**Medway Planning & Economic Development Board
Meeting**

DPW 19 Populatic Street
Storge Canopy

Subject: Populatic WTP – Proposed Storage Canopy – Supplemental Information

Subject: Medway WTP Draft Final Plan Review

Front View

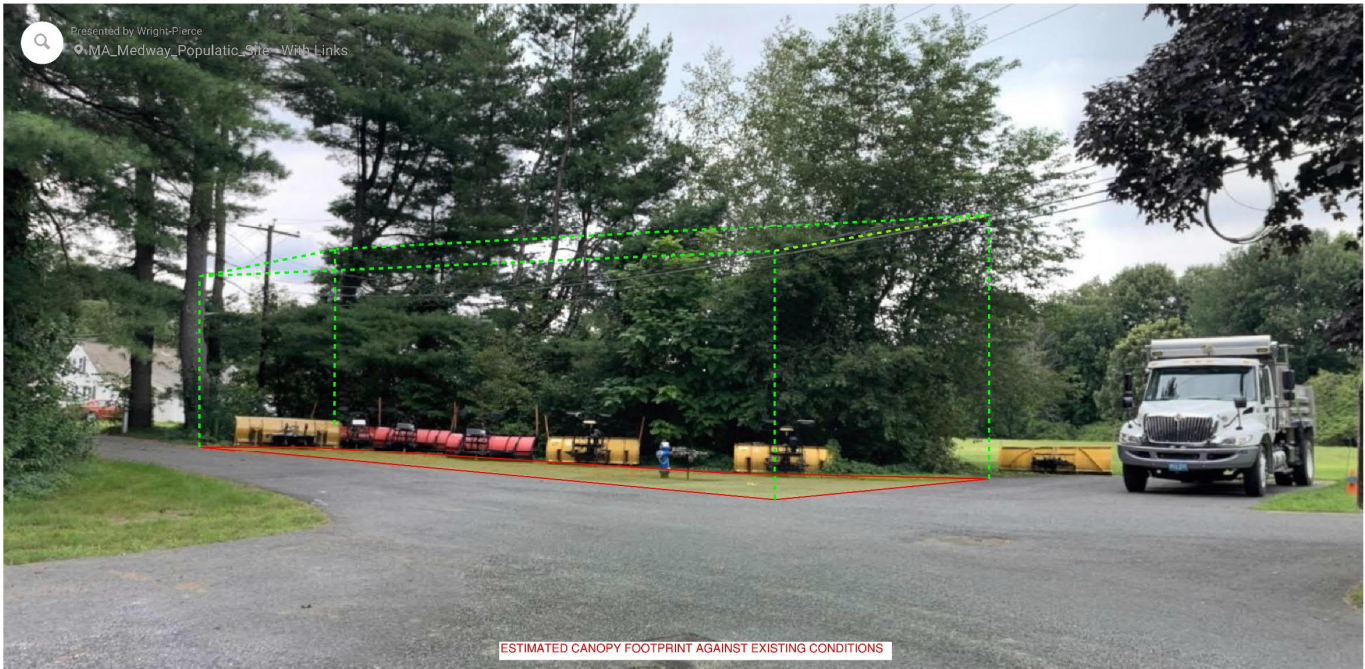
The proposed design of the canopy will closely resemble the storage canopy that has been built at the newly constructed DPW Facility. Some primary differences to note from the DPW facility design include a plastic membrane roof in lieu of the insulated metal panel roof, the elimination of the gutters, and a smaller overall footprint. The height of the proposed canopy will be similar to the DPW facility with a low side height of approximately 16-ft and high side height of approximately 18-ft. Refer to the photos below:

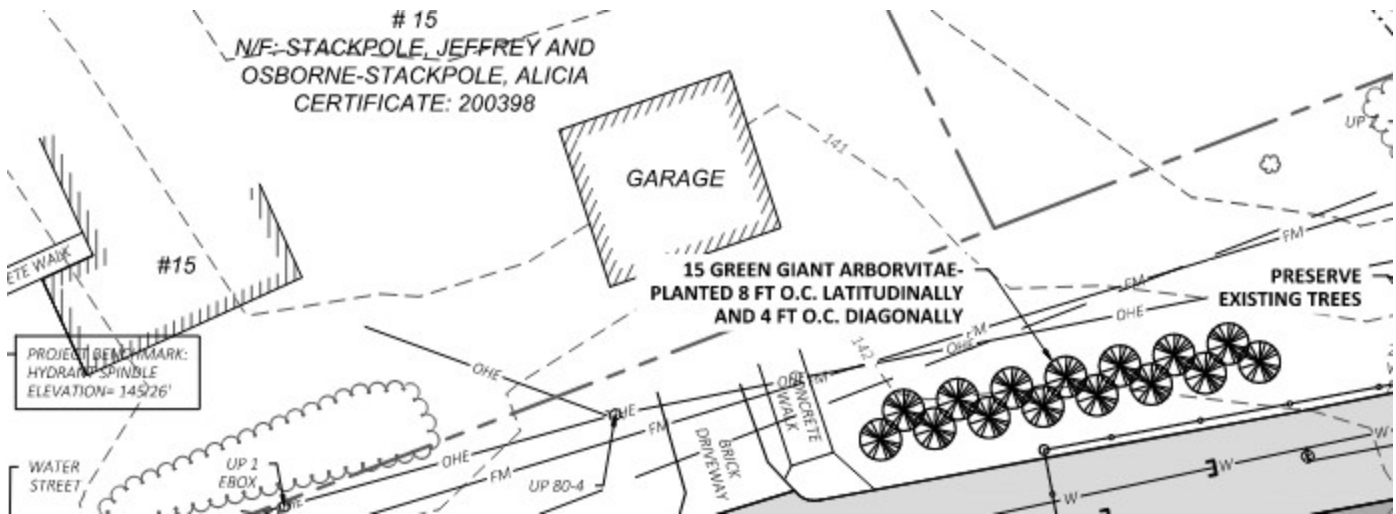
4. It does not appear additional landscaping is proposed to screen the Storage Canopy location as compared to the previous Plan Set. (VIII.D.7) **JEC: We discussed adding more landscaping to screen the canopy with our landscape architect. We were having a hard time determining what additional landscaping would really be needed. The goal was to screen the canopy from the abutting neighbor (#15 Populatic) as best we could and what we are showing now for screening appears adequate. There is not a lot open space to add additional plantings along that side of Water Street. We are keeping 3 large existing pines in place that already provide significant screening and we are also keeping the existing vegetation behind the proposed structure. So it's essentially surrounded by vegetation/screening. We also added a row of 15 Arborvitae to provide even more additional screening. See below. What is the PEDB's expectation for screening? We can certainly add more if needed, we just need some direction on where/what they would like added.**
